MEMORANDUM

RE: Hydrogeological Update (January 4, 2017 Meeting Summary)
13610 Banks Crescent, Summerland, BC

SUMMERLAND
INDEPENDENT AND ASSISTED LIVING
EROSION AND SEDIMENT
CONTROL PLAN
PROJECT No.16028
DRAWING No.SK-06
SCALE 1:1500
December 23, 2016

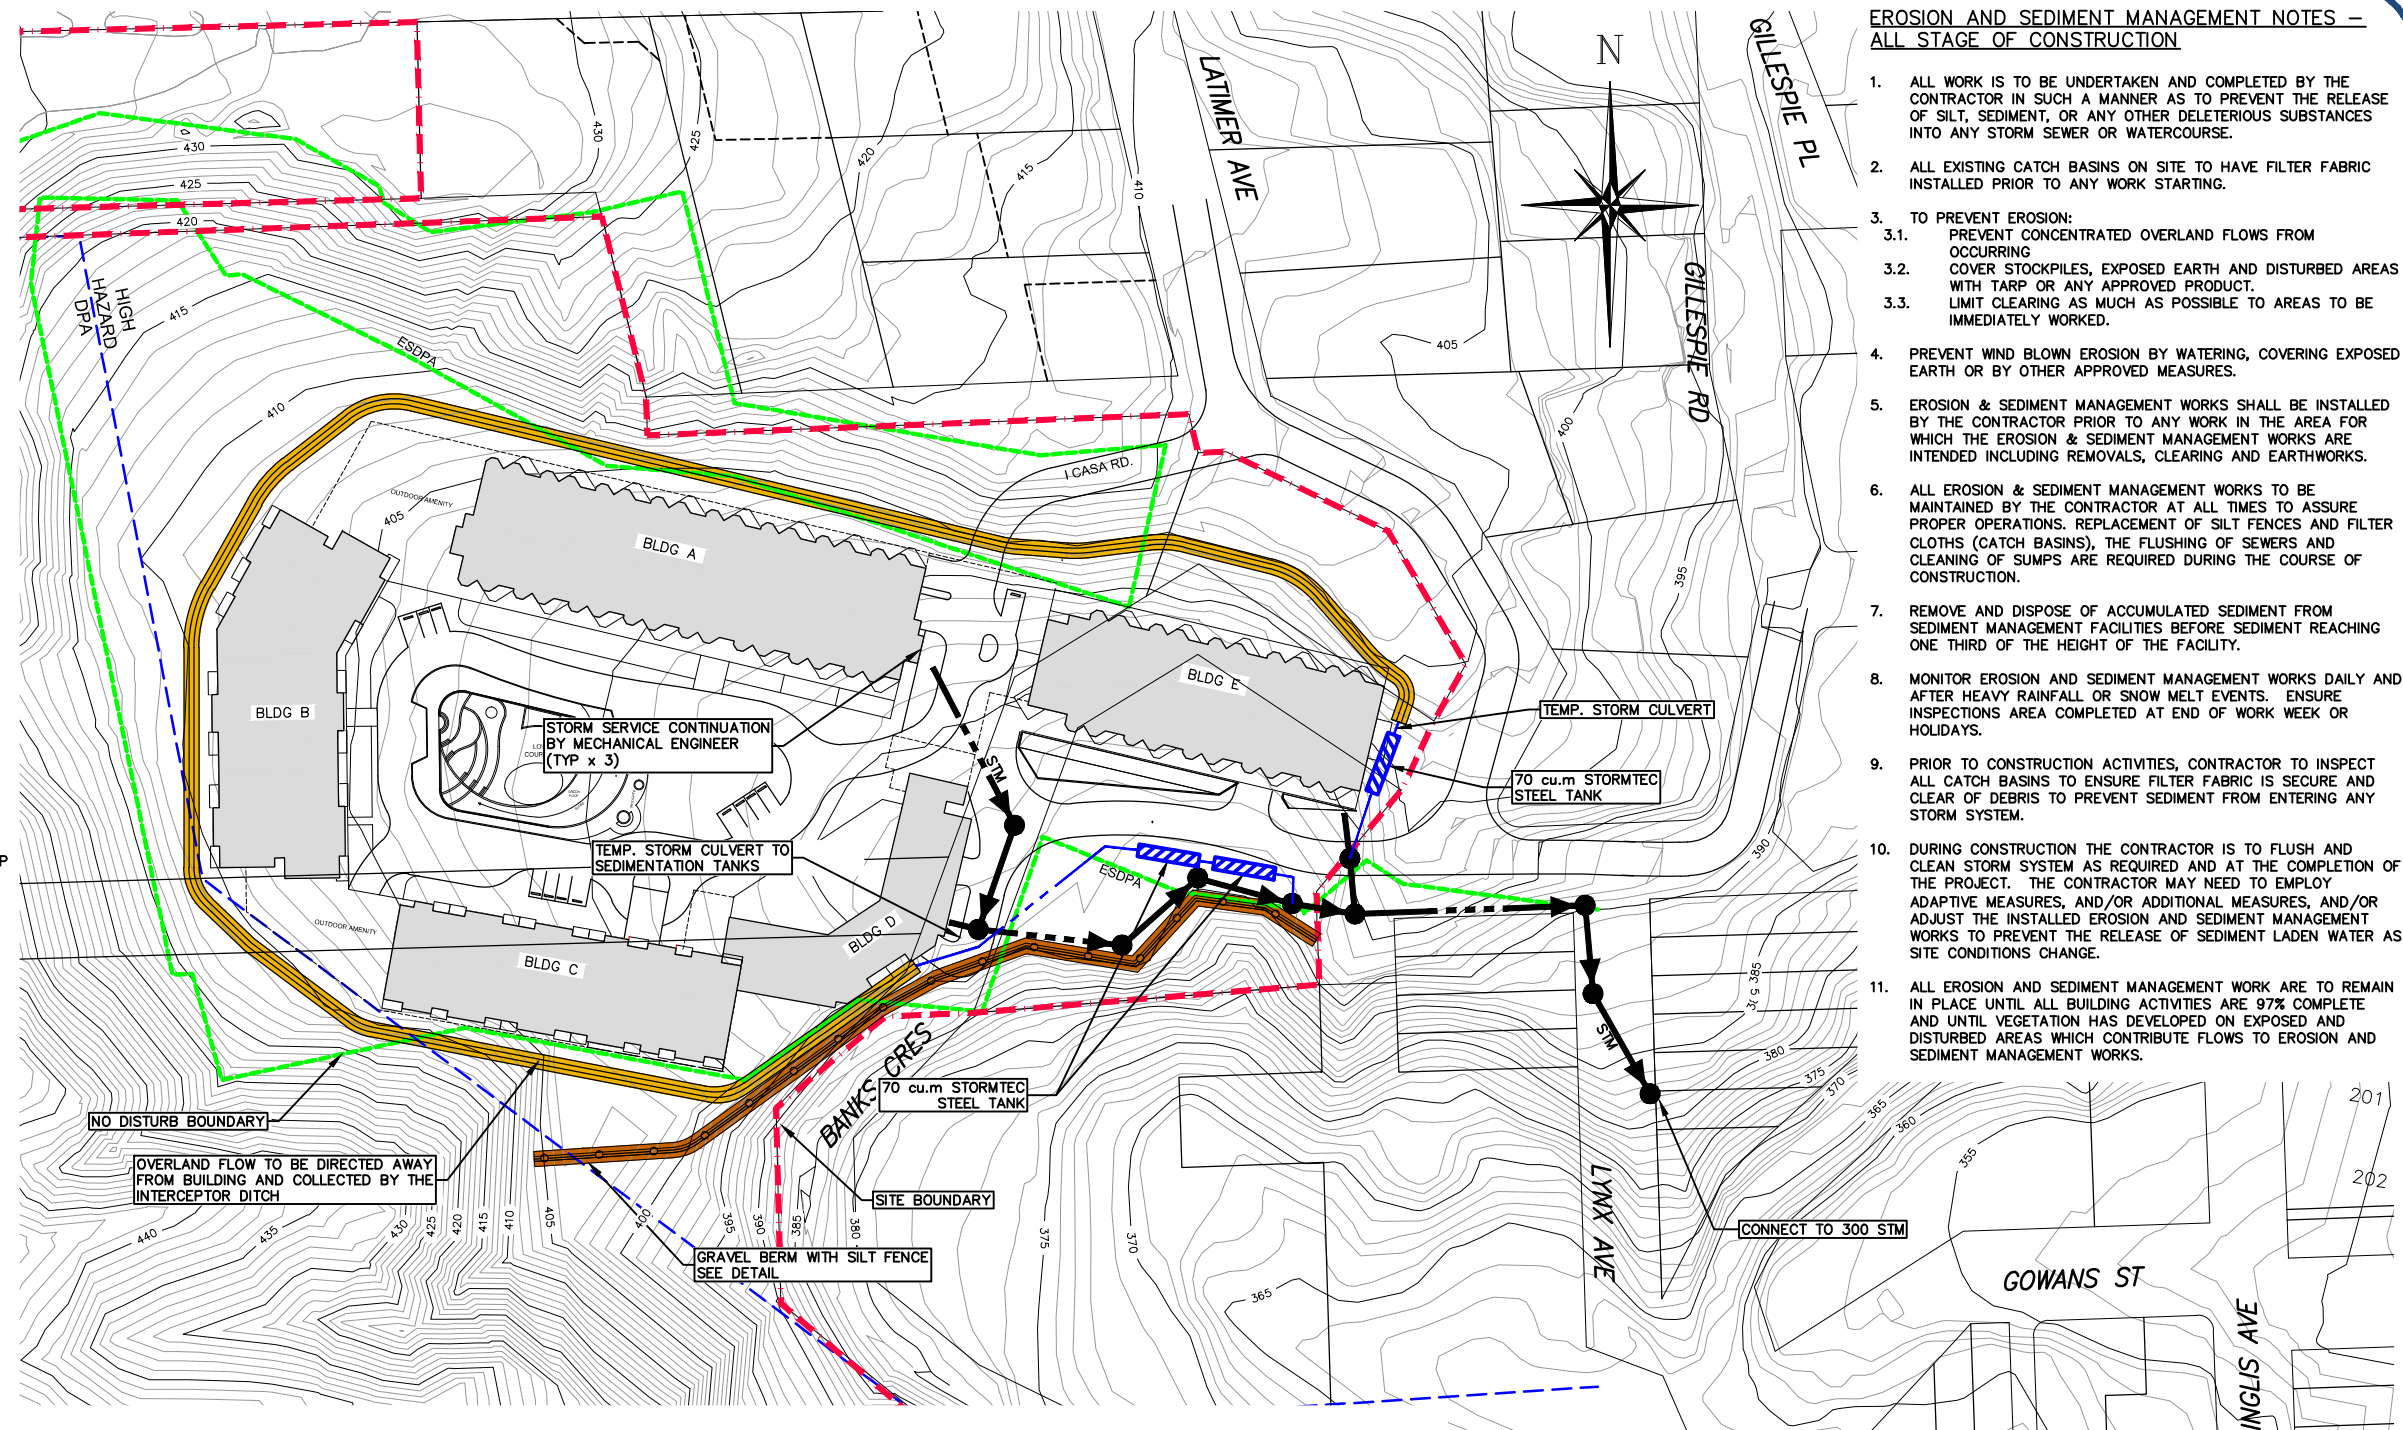
- 5) Erosion-induced turbidity within the Spring has two interpreted generation mechanisms, including mobilization of fine sediment during high precipitation events and the rapid release of material from the slope (sloughing). Erosion-induced turbidity is interpreted to be a higher risk to water quality. Such turbidity events result when high intensity precipitation events mobilize sediment-laden runoff.

To mitigate against impacts associated with erosion-induced turbidity generated from the slopes below the Site, tiered silt fencing will be constructed on the vegetated portion of the slope above the Spring. Timing for installation of these works will be conducted in coordination with FFSBC.

The risk associated with erosion-induced turbidity is significantly reduced with the implementation of a system of tiered silt fences that are properly installed, monitored and maintained. The current ESCP concept drawing (attached) provides details regarding the proposed silt fencing. Ultimately, the locations of the silt fencing will be agreed to with FFSBC. With the incorporation of silt fencing, the risk associated with erosion-induced turbidity is interpreted to be low.

Action: Incorporate above described measures in the ESCP.
